Manufacturer's Ref Number: CT-20-00324

## Urgent Field Safety Notice (FSN) Niobe ES Potential Fire Hazard

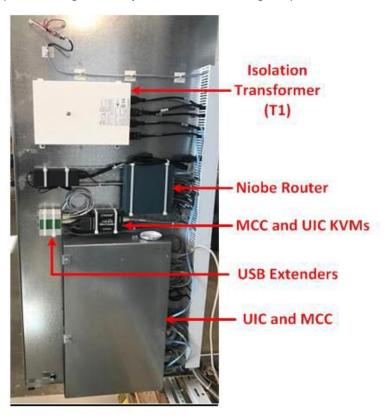
2 Reason for Field Safety Corrective Action (FSCA)*		
2	Description of the product problem*		
	A SATA cable in the Niobe computer cabinet was designed in a way that could lead to		
	electrical arcing.		
2	2. Hazard giving rise to the FSCA*		
	Electrical arcing can cause a fire in the Niobe cabinet.		
2	3. Probability of problem arising		
	Based upon information from the manufacturer of the cable there is a 0.02% chance that		
	electrical arcing can occur during the lifetime of these cables		
2	4. Predicted risk to patient/users		
	It is anticipated that if this event to recur, damage to personnel could include burns and		
	smoke inhalation.		
2	5. Background on Issue		
	A fire in the Magnet Controller Computer was reported on 12 AUG 2020. The fire was		
	contained within the computer cabinet and was extinguished with no injuries. It was		
	discovered that the SATA cable inside the computer had arced, resulting in the fire.

4. Open the swing door and you will see the following components

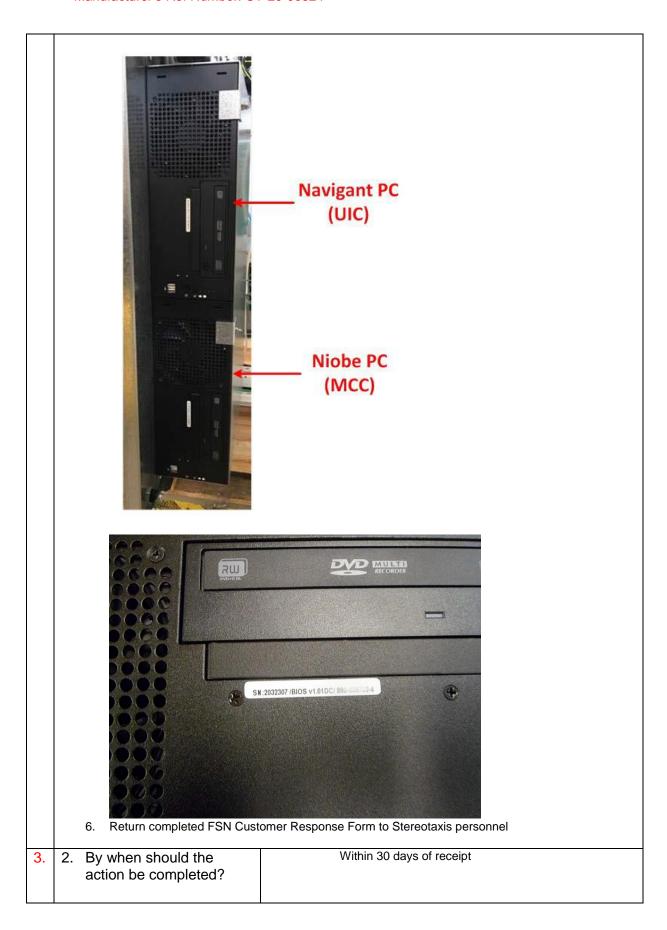
3. Type of Action	to mitigate the	risk*
3.	1.	Action To Be T	aken by the User*		
		□ Identify Device	☐ Quarantine Device	☐ Return Device	☐ Destroy Device
		☐ On-site device m	odification/inspection		
		☐ Follow patient management recommendations			
	$\hfill\Box$ Take note of amendment/reinforcement of Instructions For Use (IFU)				
		☐ Other	□ None		
	Please respond to this FSN with the Serial Number of the MCC and UIC in the Niobe computer cabinet. Please follow these steps in order to identify the Serial Numbers. Please contact Stereotaxis personnel if assistance is required.				
	1. Locate the Niobe Computer Cabinet  2. Open Niobe Computer Cabinet

5. Record UIC and MCC Serial Numbers on FSN Customer Response Form
